DIFFERENCES BETWEEN 218RBE AND 198RBE

U902B/CRT DRIVE BOARD PW6890-2(218R8E)
PW9800-2(198R8E)

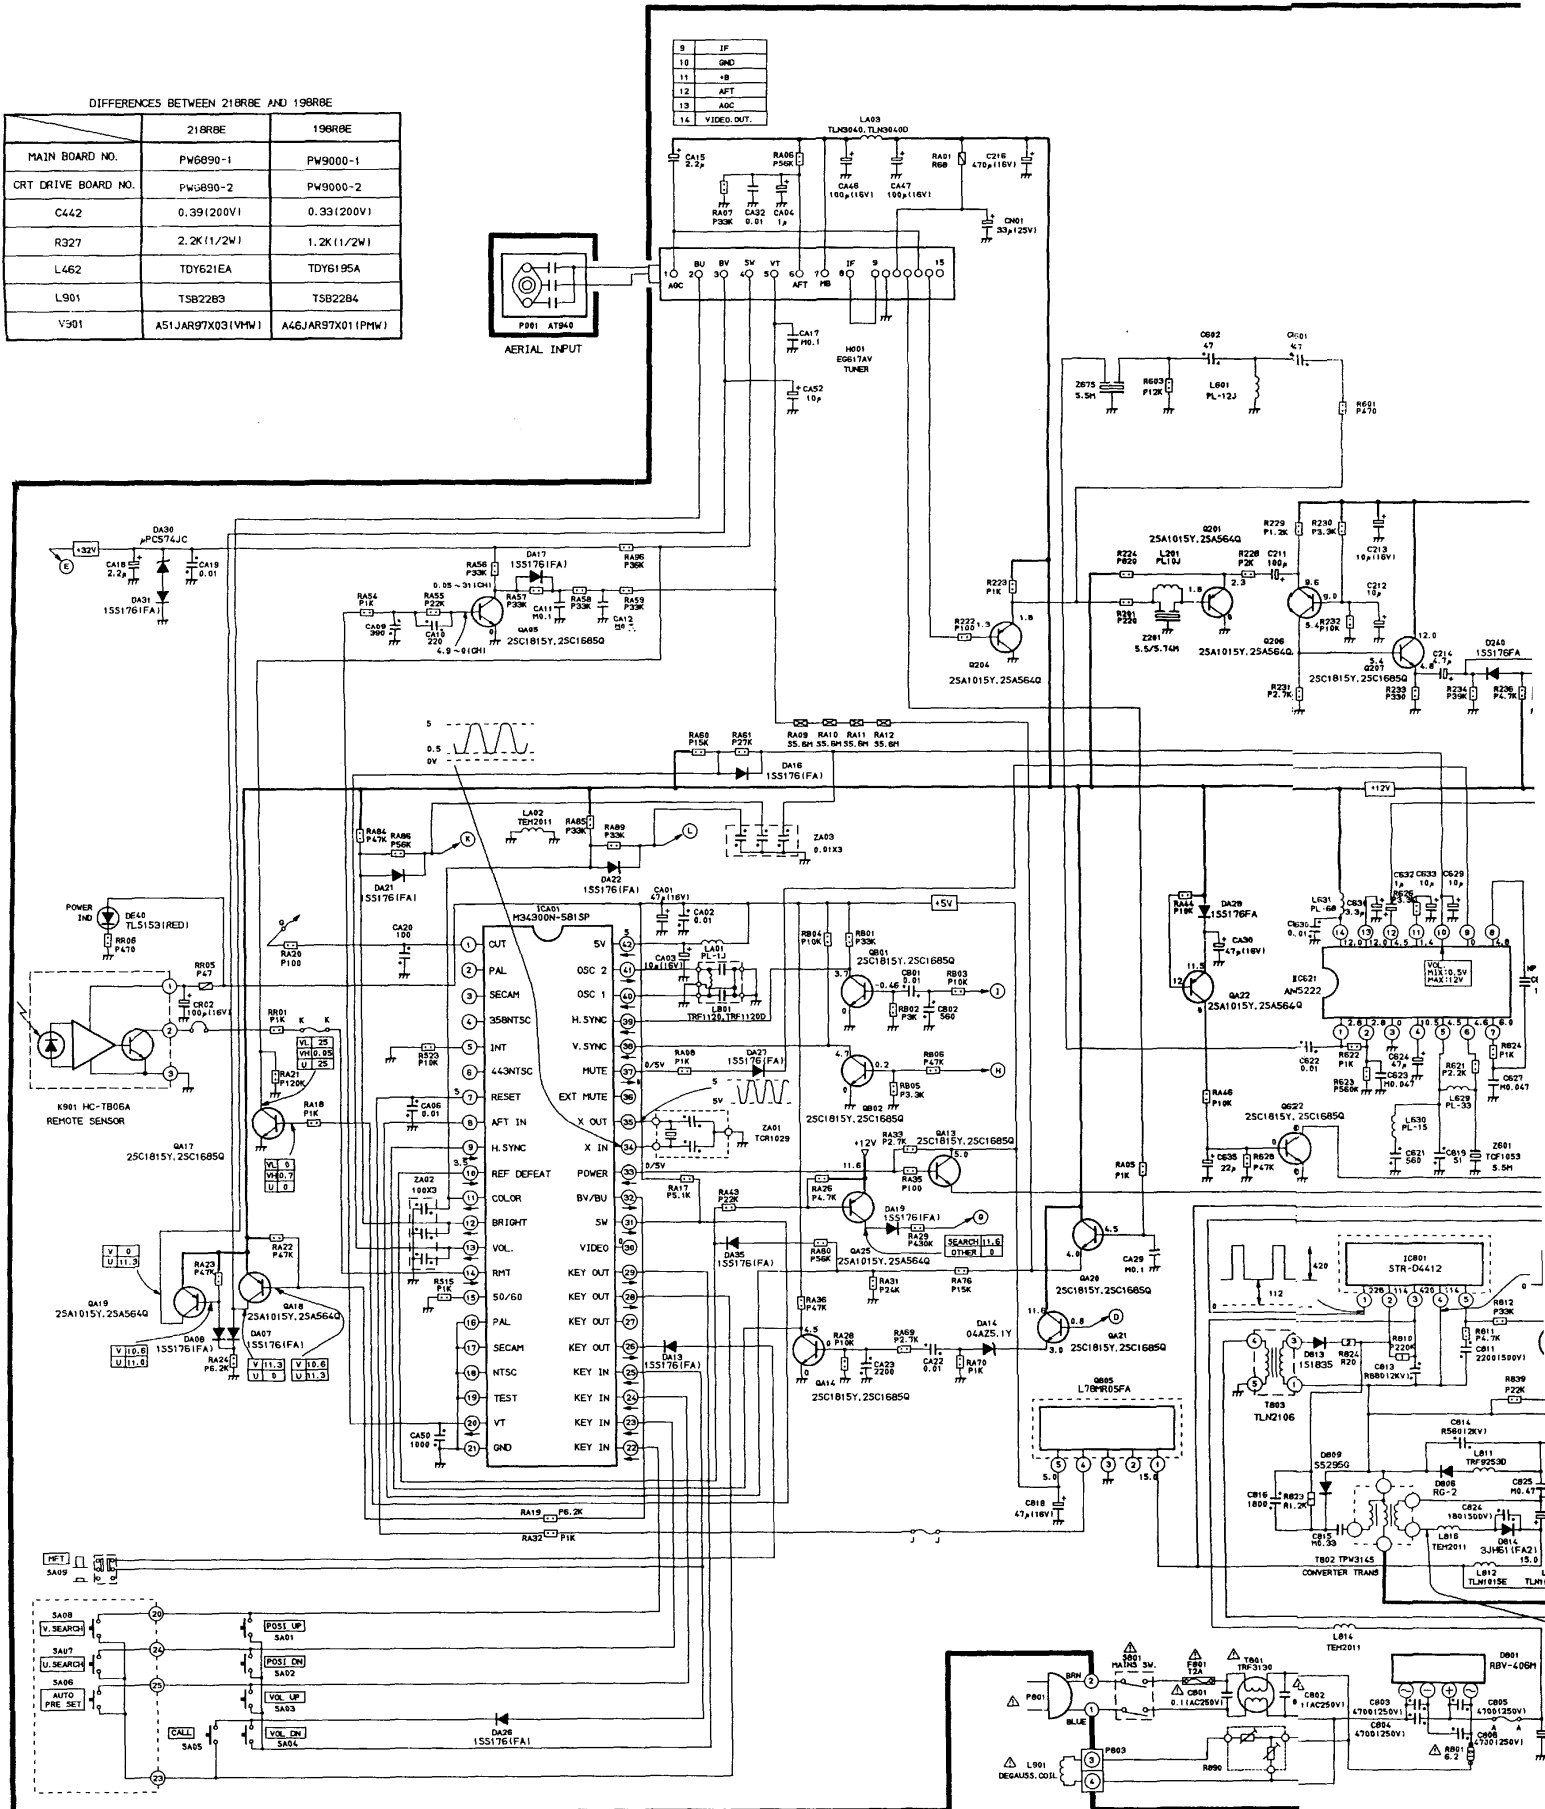
218RBE	198RBE
MAIN BOARD NO.	PW6890-1	PW9000-1
CRT DRIVE BOARD NO.	PW6890-2	PW9000-2
C442	0.39(200V)	0.33(200V)
R327	2.2K(1/2W)	1.2K(1/2W)
L462	TDY621EA	TDY6195A
L901	TSB2283	TSB2284
V901	A51JAR97X03(VPW)	A46JAR97X01(PW)
